THE RETREAT AT OAKHILLS

PUD/POADP PLAN (date) July 2, 1999 (number) 637

Re: The Retreat at Oakhills Subdivision

POADP # 637

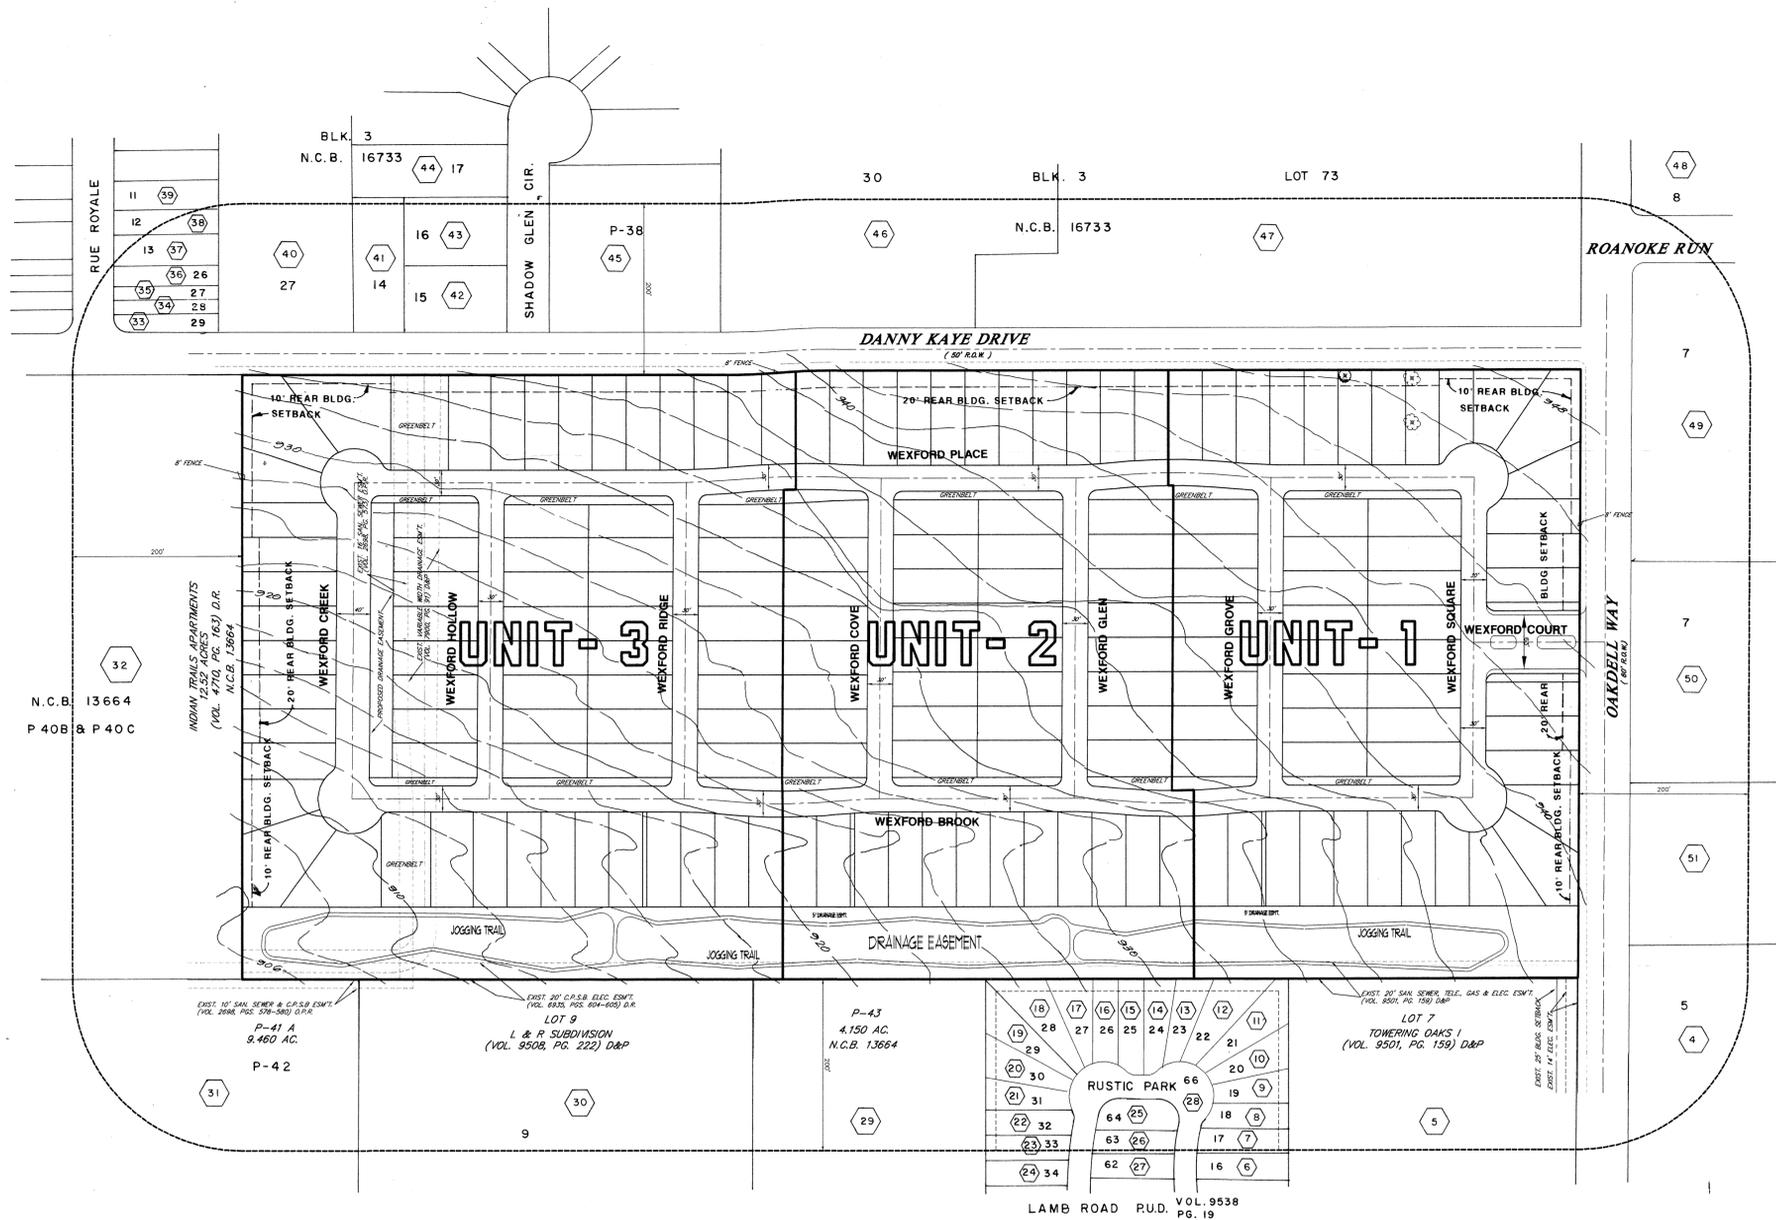
The City Staff Development Review Committee has reviewed The Retreat at OakHills Subdivision Preliminary Overall Area Development Plan # 637. Please find enclosed a signed copy for your files. Although your plan was accepted, please note the following:

- Based on the topography, a Flood Plain Study and drainage review will probably be required during the platting process.
- This development will need to comply with tree preservation ordinance #85262. For information about these requirements you can contact Building Inspections at 207-7102.
- It will be expected that you will plat all of the property depicted in your POADP, to include: floodpains, drainage areas and open space.
- I would encourage you to work closely with the school district, so that they can plan accordingly.
